42 HONEYSUCKLE DRIVE COTTAGE CREEK PRECINCT NEWCASTLE

STATE SIGNIFICANT DEVELOPMENT (SSD-10378)
DEVELOPMENT MODIFICATION 2

ARCHITECTURAL DESIGN STATEMENT

NOVEMBER 2021

1.1 DESIGN CHANGES FIRST FLOOR

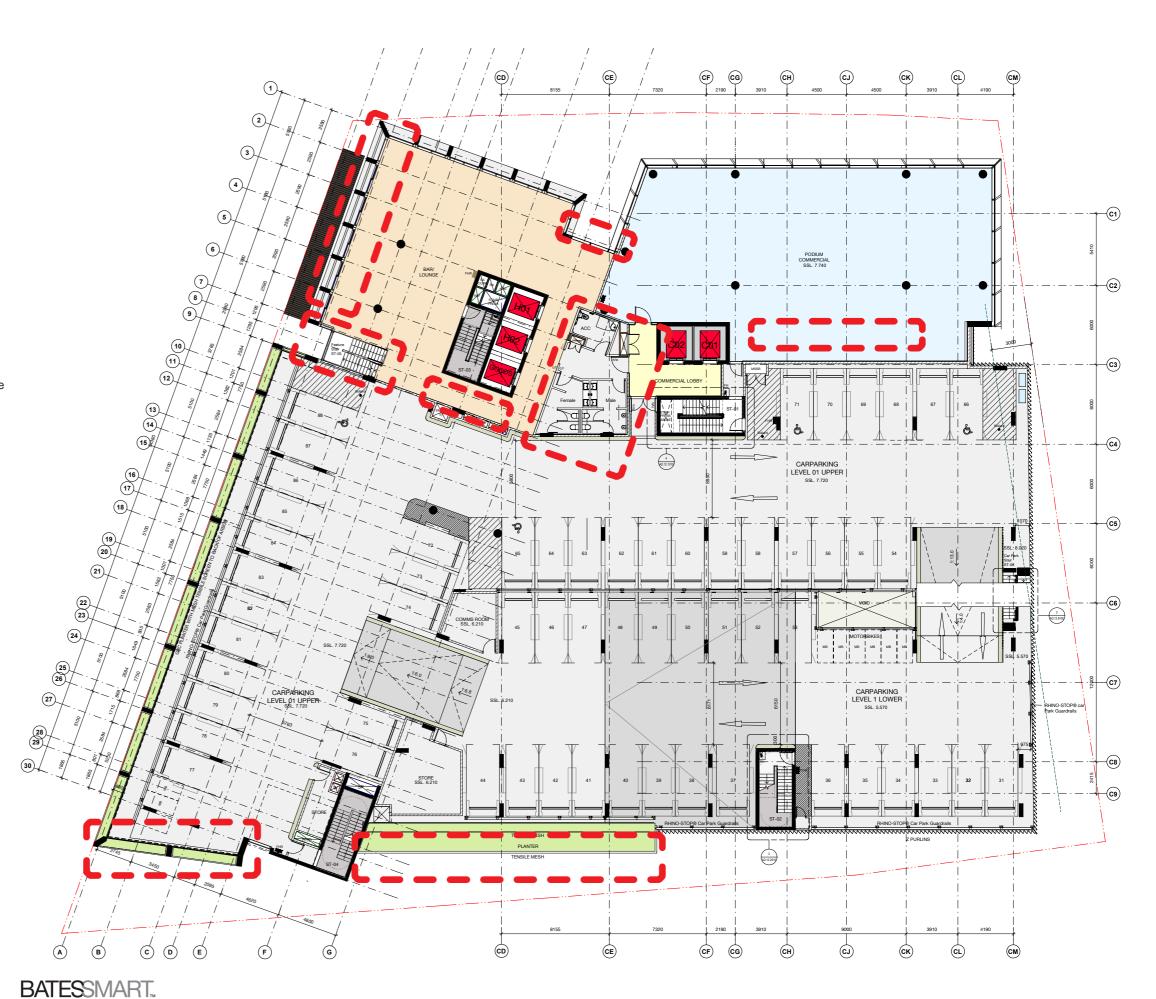
- $1\,/$ South west end of the building at levels L00/L01/L02 set back from south boundary line.
- 2/ Amenities to commercial floor area shifted and combined with the hotel facilities.
- 3 / Feature stair relocated to the western side of the communal space. Stair links from ground floor to level L02.
- $4\,\mbox{/}$ External western terrace off the hotel communal space omitted.
- 5 / Planter between building forms along the Northern elevation at levels L01 and L02 omitted.
- $6\,\slash$ Loss of 1 parking space due to a reduction in the western elevation length

2.1 DESIGN CHANGES SECOND FLOOR

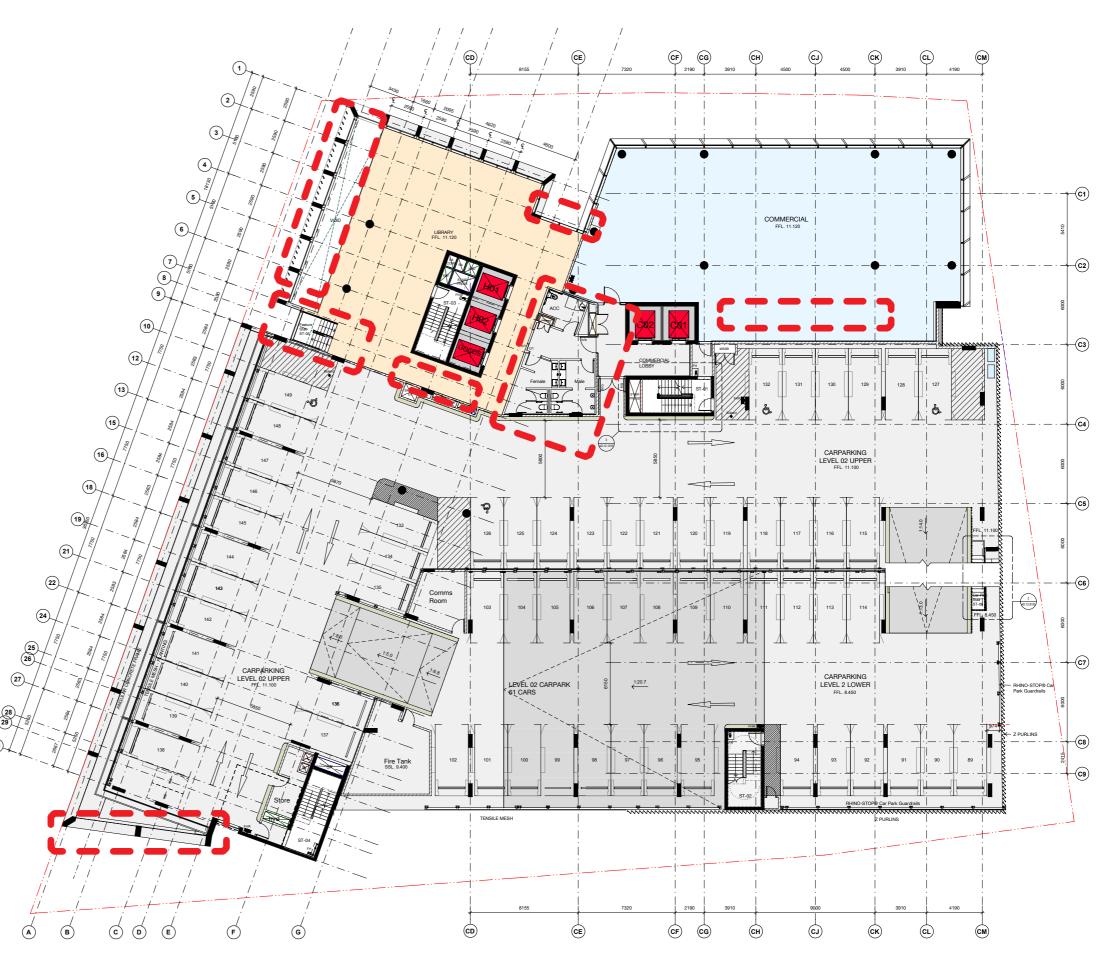
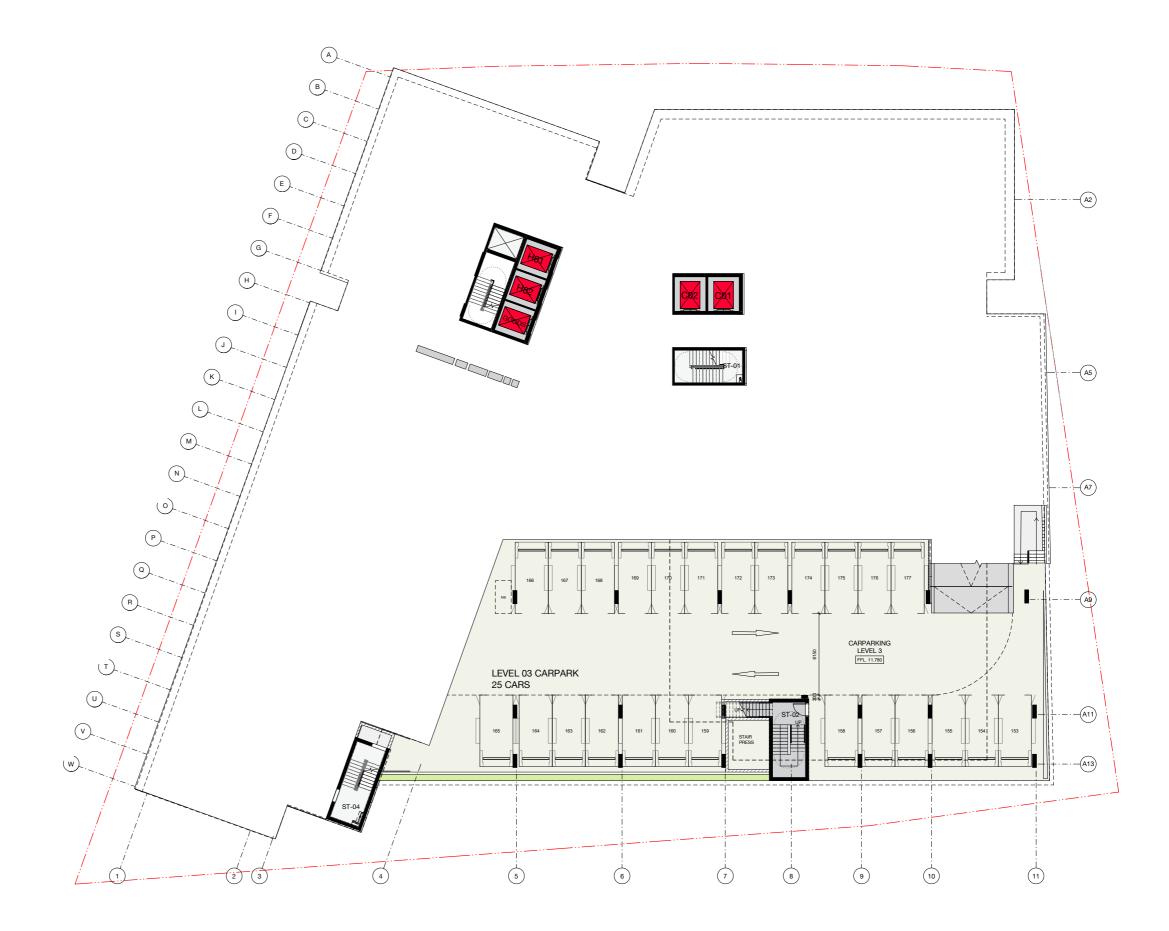
- $1\,/$ South west end of the building at levels L00/L01/L02 set back from south boundary line.
- 2/ Amenities to commercial floor area shifted and combined with the hotel facilities.
- 3 / Feature stair relocated to the western side of the communal space. Stair links from ground floor to level L02.
- $4\,\mbox{/}$ External western terrace off the hotel communal space omitted.
- 5 / Planter between building forms along the Northern elevation at levels L01 and L02 omitted.
- 6 / Loss of 1 parking space due to a reduction in the western elevation length

3.1 DESIGN CHANGES THIRD FLOOR PARKING

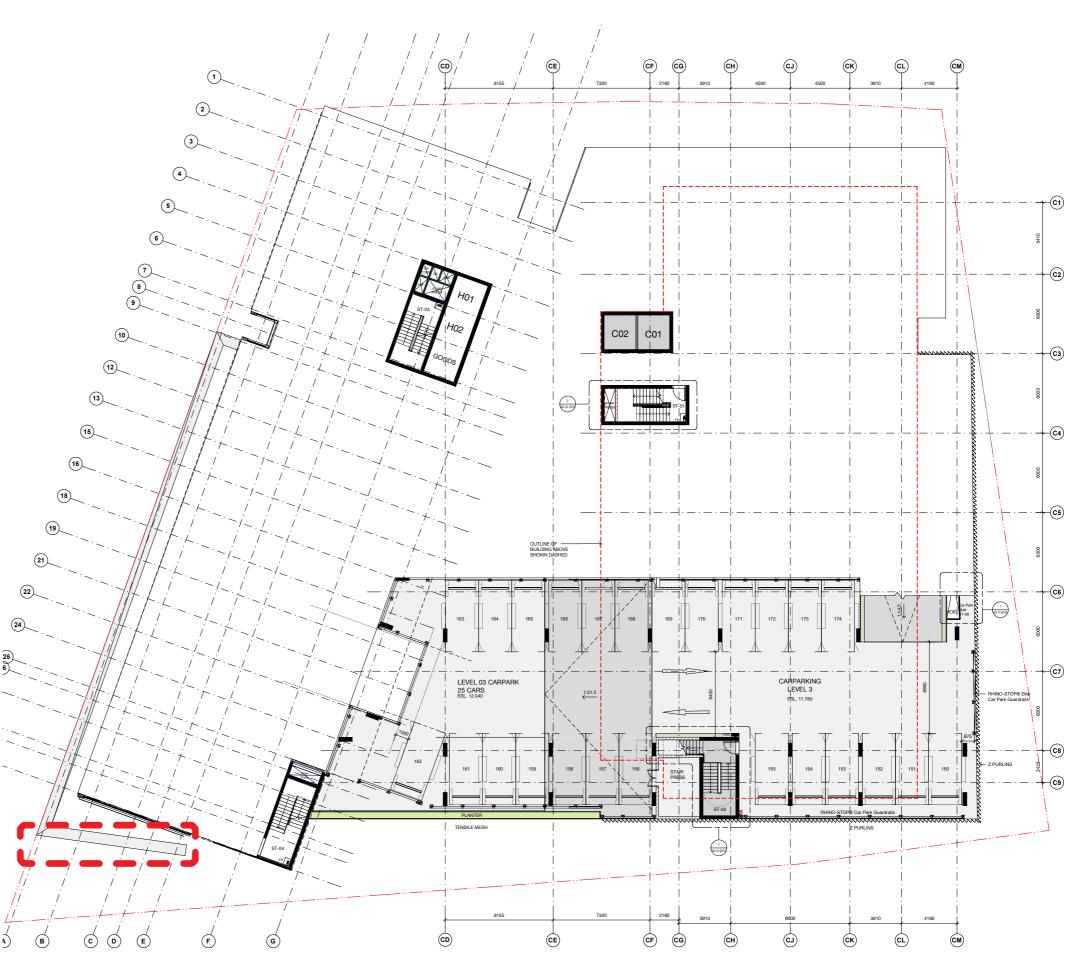
$1\,/$ South west end of the building at levels L00/L01/L02 set back from south boundary line.

3.3 DESIGN CHANGES THIRD FLOOR COMMERCIAL & HOTEL

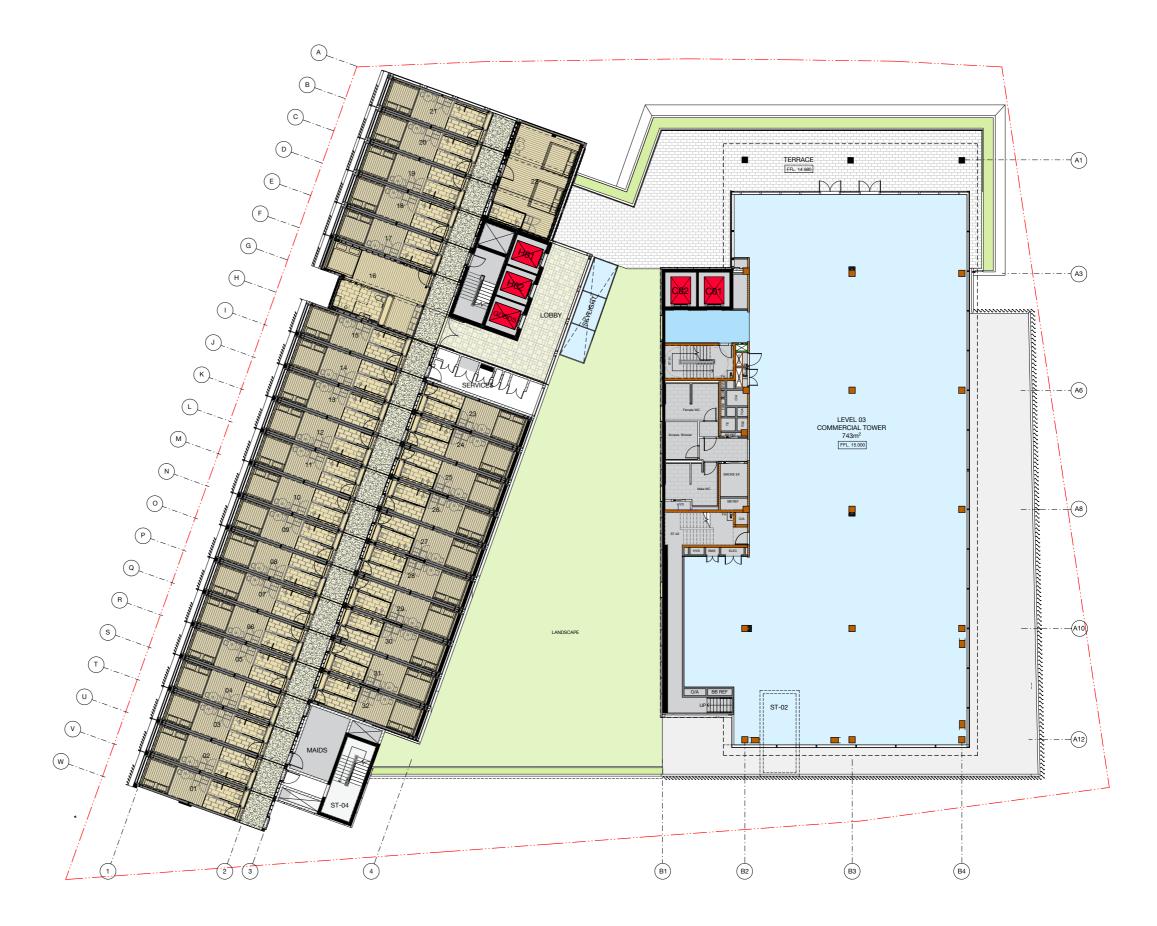
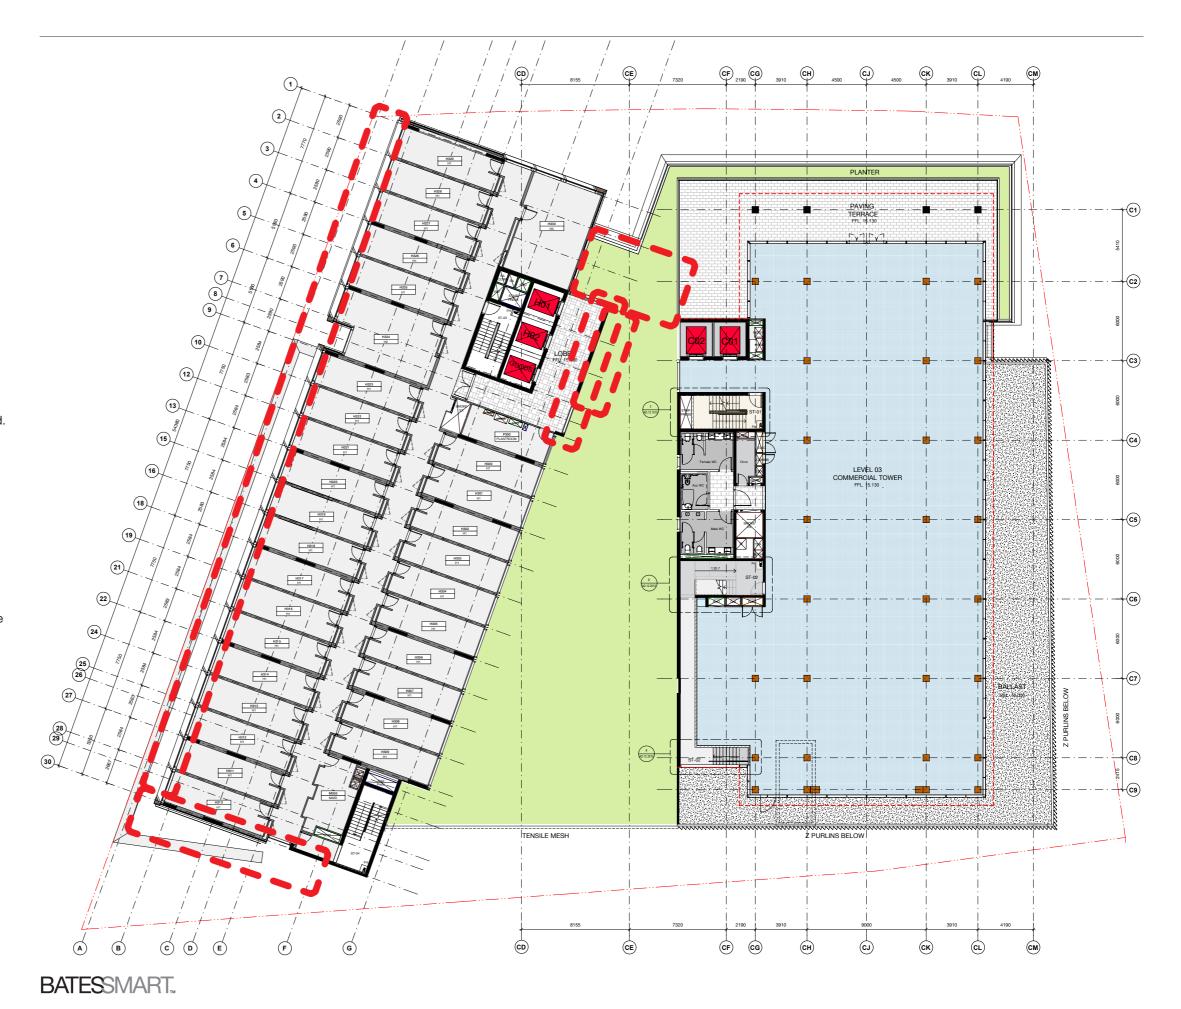
- 1 / South west end of the hotel 1 room from every level omitted.
- 2 / Western hotel facade sunshading design amended
- 3 / Skylight over feature stairs below omitted.
- $4\,\slash$ Landscaped area to the northern terrace increased.
- $\,$ 5 / Hotel modular construction methodology amended to a traditional built form.
- 6 / Facade amended outside lift lobby. This is now concrete construction rather than glazing to increase privacy between the hotel and commercial tower.

4.1 DESIGN CHANGES FIFTH - SEVENTH FLOOR TYPICAL

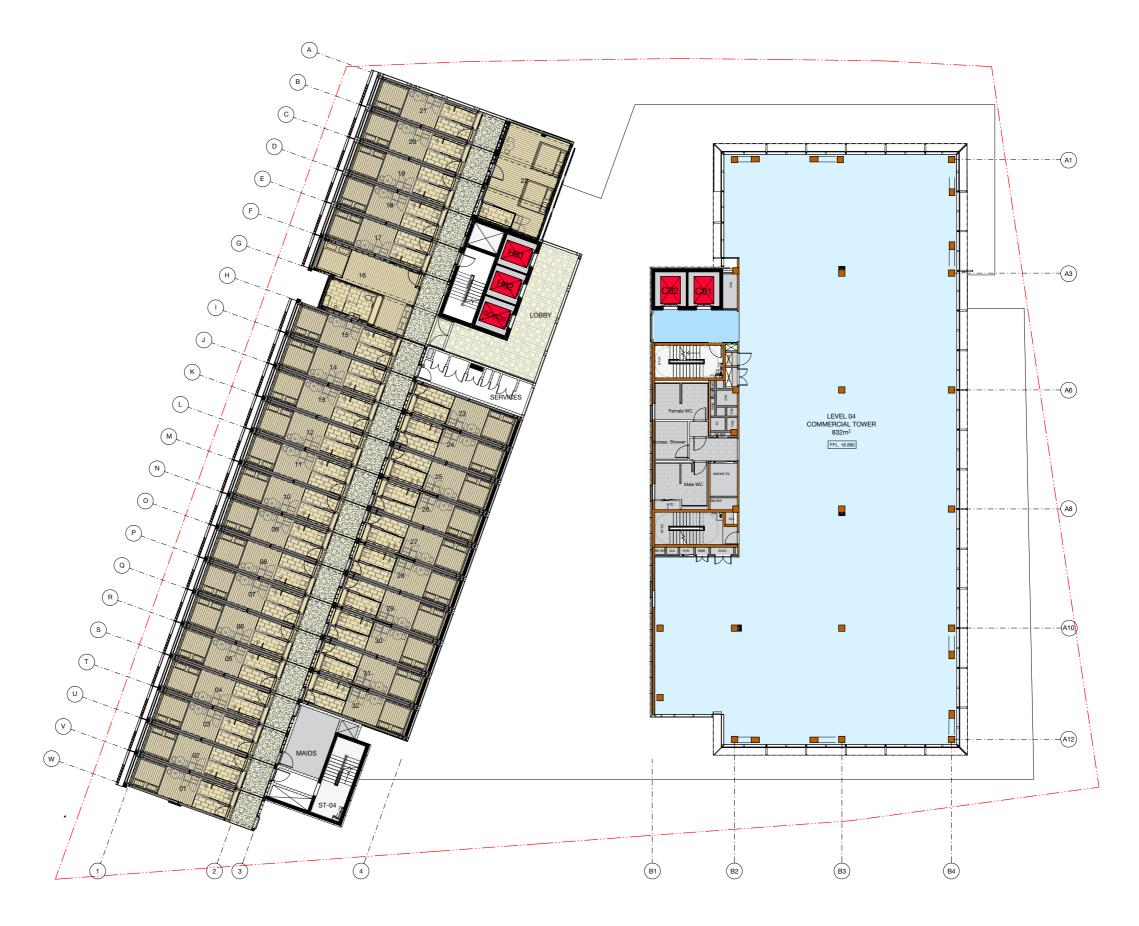
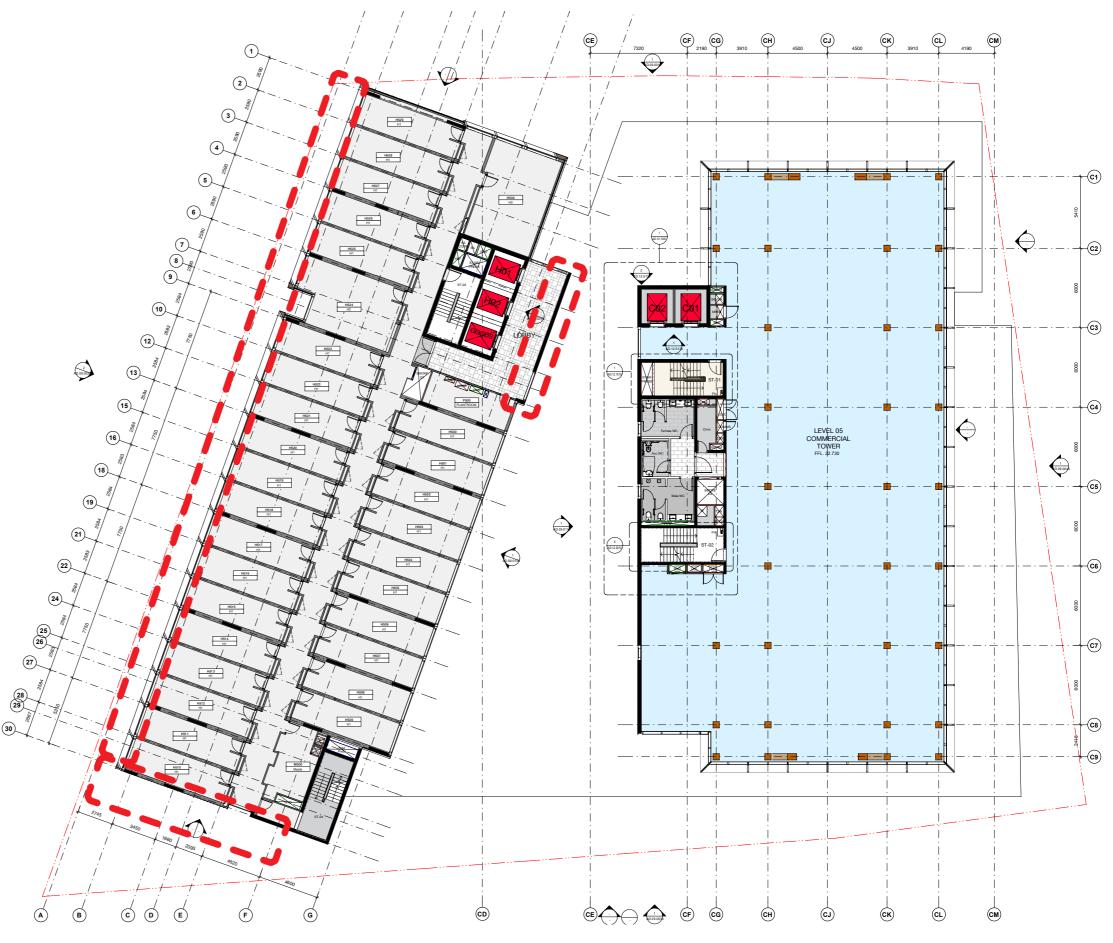
- 1 / South west end of the hotel 1 room from every level omitted.
- 2 / Western hotel facade sunshading design amended
- $3\,\mbox{/}$ Hotel modular construction methodology amended to a traditional built form.
- 4 / Facade amended outside lift lobby. This is now concrete construction rather than glazing to increase privacy between the hotel and commercial tower.
